ALERT SERVICE BULLETIN

NO. 214ST-09-87

SUBJECT: **INSPECTION/CHANGE OF RESTRAINT SYSTEM ASSEMBLY WITH INERTIA REEL AND MANUAL LOCK HANDLE**

SERVICE BULLETIN NUMBER 501836-25-01 ISSUE 1

Figure 1 – Serial Number and Date Code Information

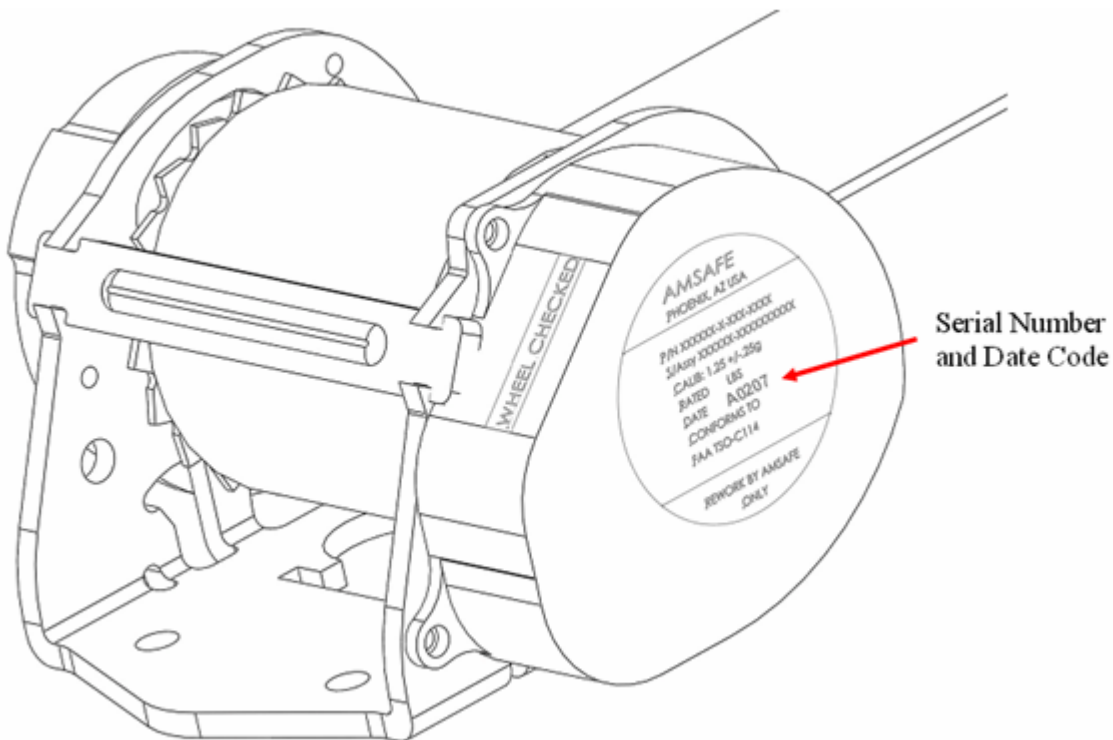
1. The inspection of the restraint system does not require the restraint system to be removed from the seat.
2. Date Code Inspection. The date code can be found on the inertia reel identification label see Figure 1. For access to the inertia reel identification label please refer to the applicable seat manufactures instruction defined in their CMM.

If the date code is prior to 1 Feb 07 (X0207) or after 30 Nov 08 (X1108) no further action is required.

Figure 2 – Wheel Checked Label

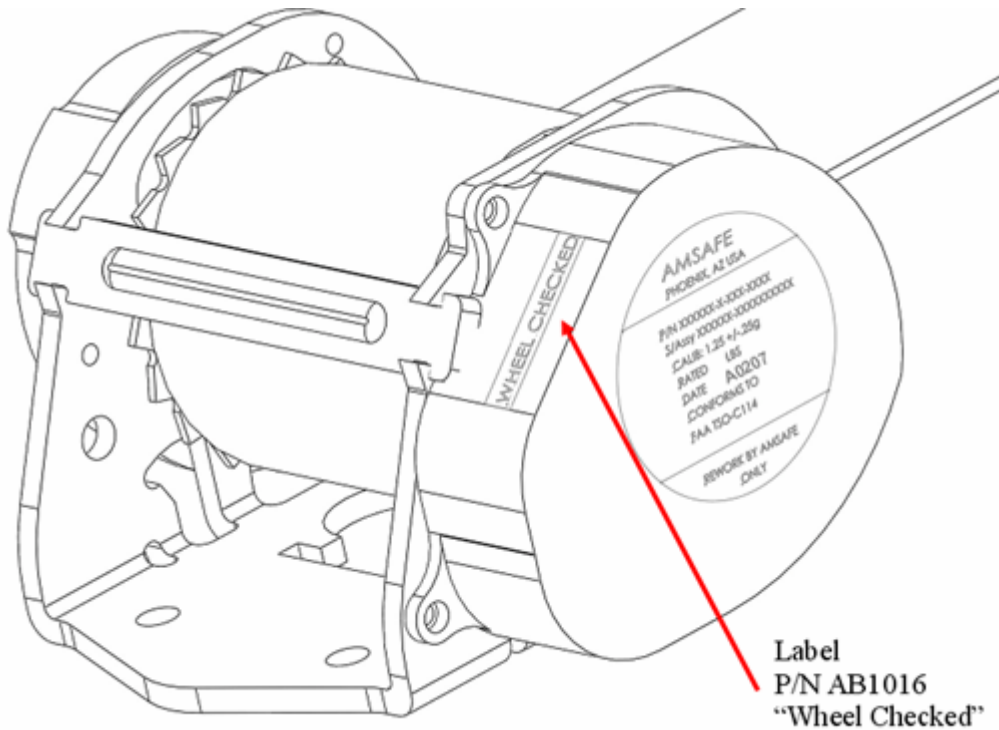
If the serial number is between 1 Feb 07 (X0207) and 30 Nov 08 (X1108), and the inertia reel does not include a label attached by AmSafe stating "Wheel Checked" (Figure 2) continue to step 3.
